Docket Number:	18-IRP-01
Project Title:	Integrated Resource Plan
TN #:	230504
Document Title:	Updated - Staff Report - Review of the City of Redding's 2018 Integrated Resource Plan
Description:	** This document supersedes TN# 229408 for accessibility purposes. **
Filer:	Courtney Wagner
Organization:	California Energy Commission
Submitter Role:	Commission Staff
Submission Date:	11/4/2019 1:48:33 PM
Docketed Date:	11/4/2019

STAFF REPORT

Review of the City of Redding's 2018 Integrated Resource Plan

**Gavin Newsom, Governor
August 2019 | CEC-200-2019-010**

Figure 1: Redding and Energy Commission Energy Forecasts 2018 — 2030 (GWh)

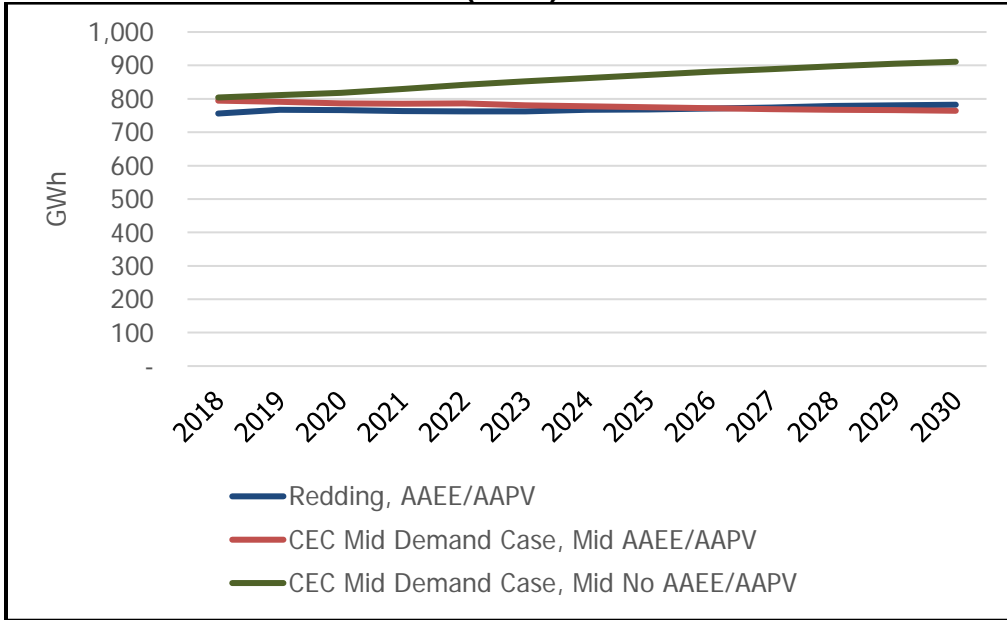
In **Figure 1**, Redding's net energy increases slightly from 767-GWh in 2019 to 782-GWh in 2030. For the system, this is a 4 percent growth over the planning period. The Energy Commission forecast is comparable to Redding's forecast for 2030, ending at 764-GWh (Mid AAEE/AAPV). The small differences between the forecasts can be attributed to how energy efficiency is calculated and incorporated into the models.

Figure 2: Redding and Energy Commission Peak Forecasts 2018 — 2030 (MW)

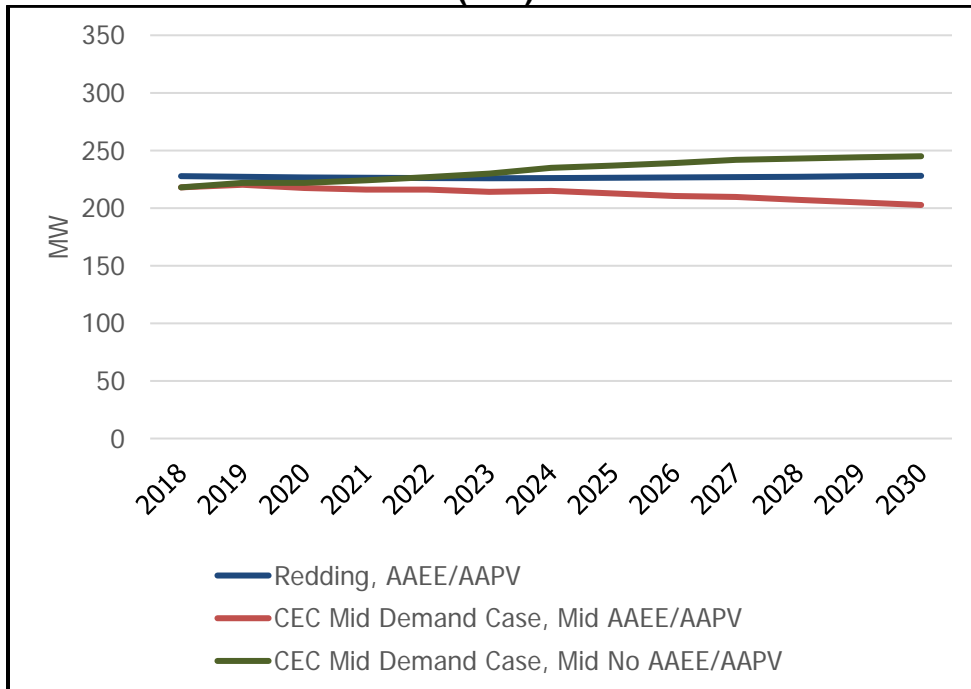
In **Figure 2**, Redding forecasts a peak demand that differs slightly from the Energy Commission's. Redding's peak demand is flat: 227-MW in 2019 to 228-MW in 2030, while the Energy Commission's shows a slow decline from 218-MW to 203-MW (Mid AAEE/AAPV) over the same period. A contributing factor for the difference may be the way weather data is normalized across the two forecasts.¹⁰
